DAIRYLAND POWER
COOPERATIVE

December 26, 2007

SUBJECT: Dairyland Power Cooperative
La Crosse Boiling Water Reactor (LACBWR)
Possession-Only License DPR-45
Annual Decommissioning Plan Revision

2007 LACBWR Decommissioning Plan Review

Figure 4.6

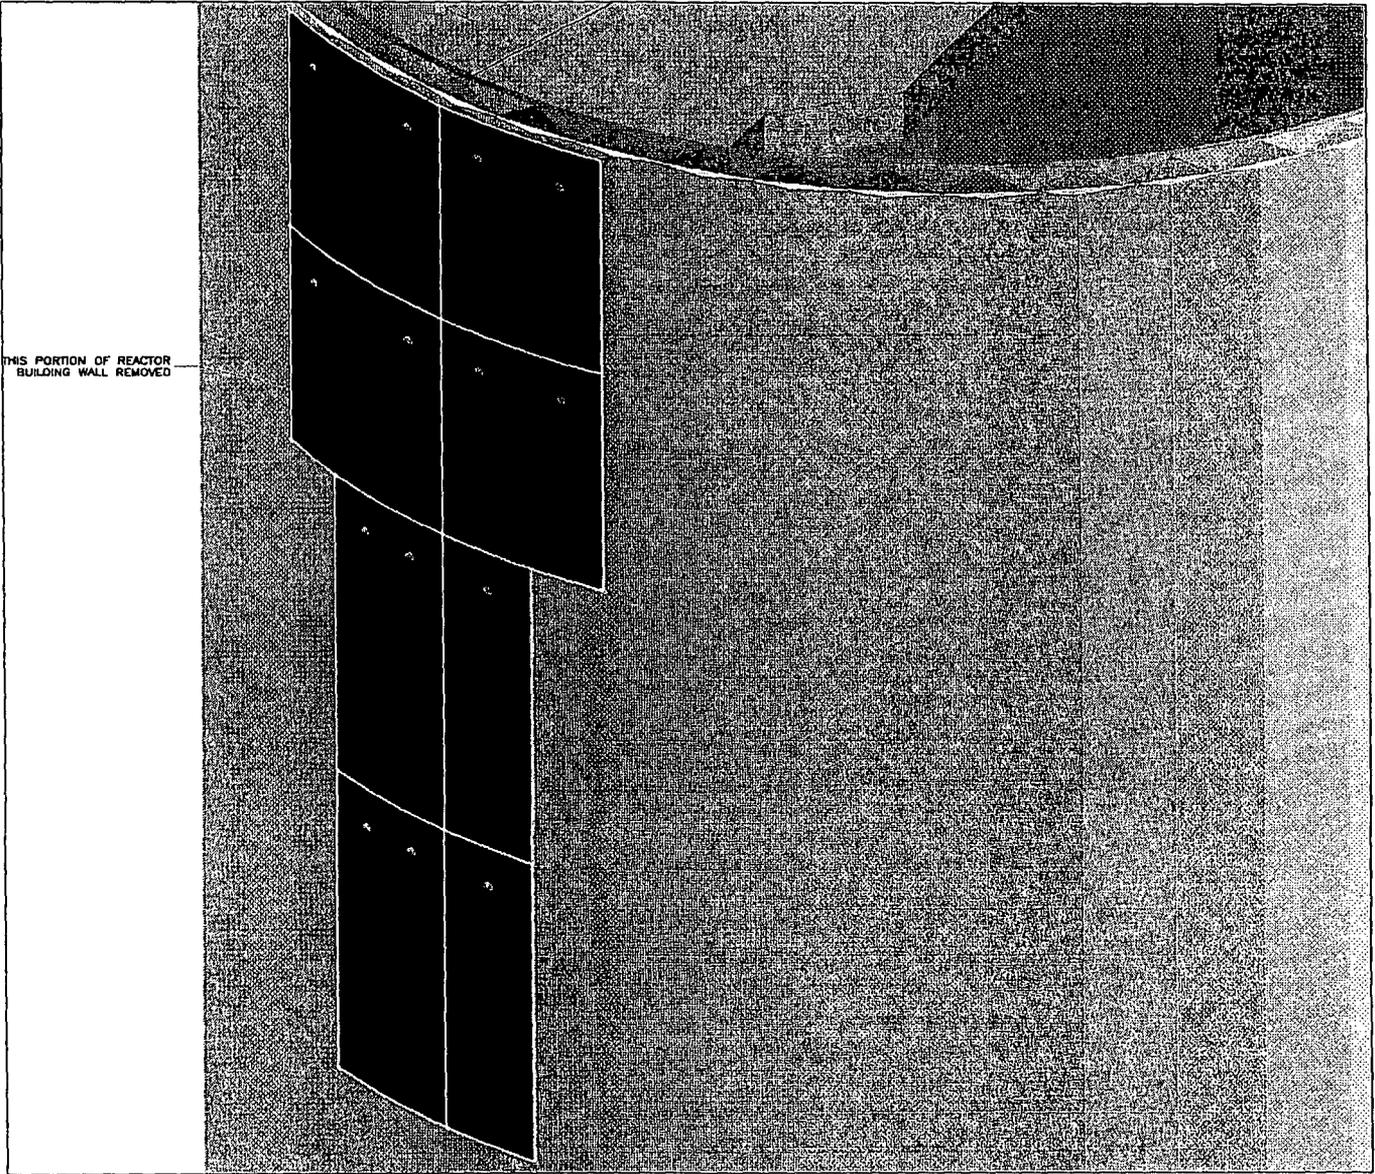
Figure 4.7 *Reactor Building Bi-Parting Door*

- Page 4-4
And
Page 4-5 Pages are issued due to content shift with no other changes.
- Section 4
Figures Figure 4.6 and Figure 4.7 are added to the section depicting the RB opening and RB bi-parting door.

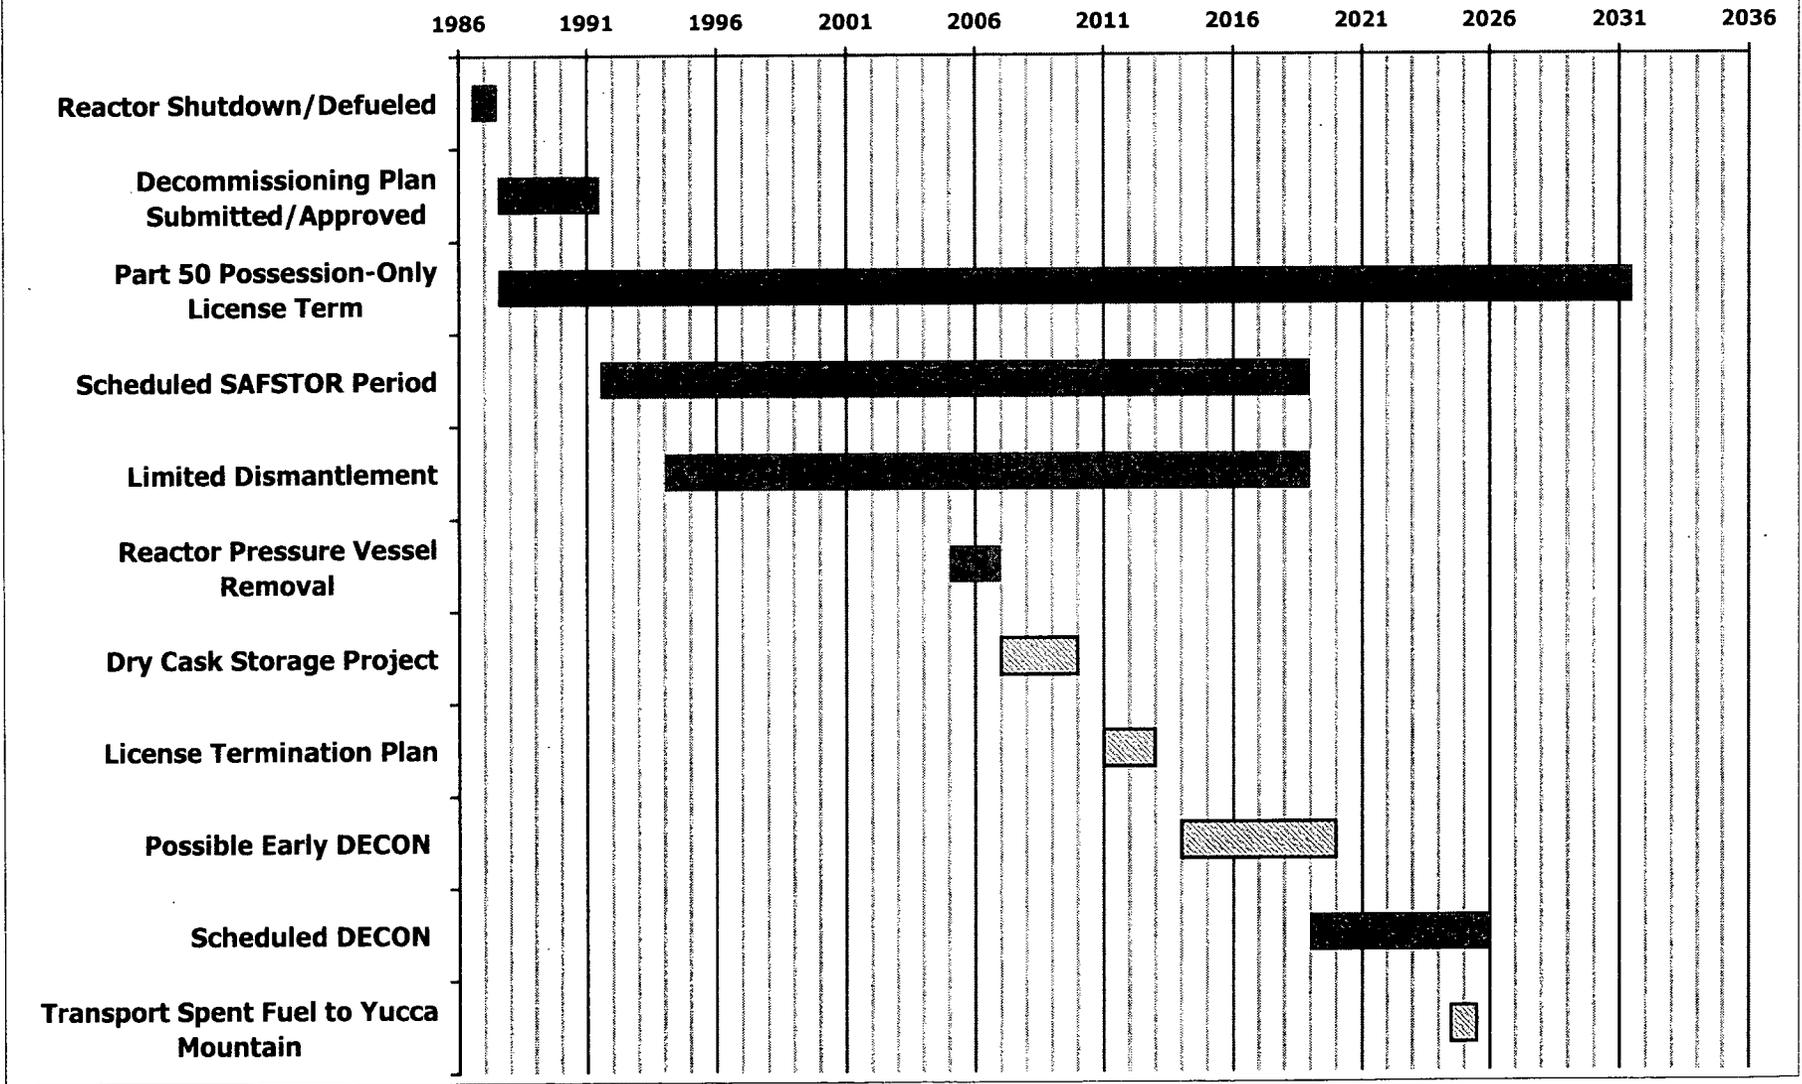
- Figure 6.2 **LACBWR Schedule:** Figure 6.2 is revised to provide a better depiction of the schedule for LACBWR as it develops. Title is shortened from “Tentative Schedule for LACBWR Decommissioning.”
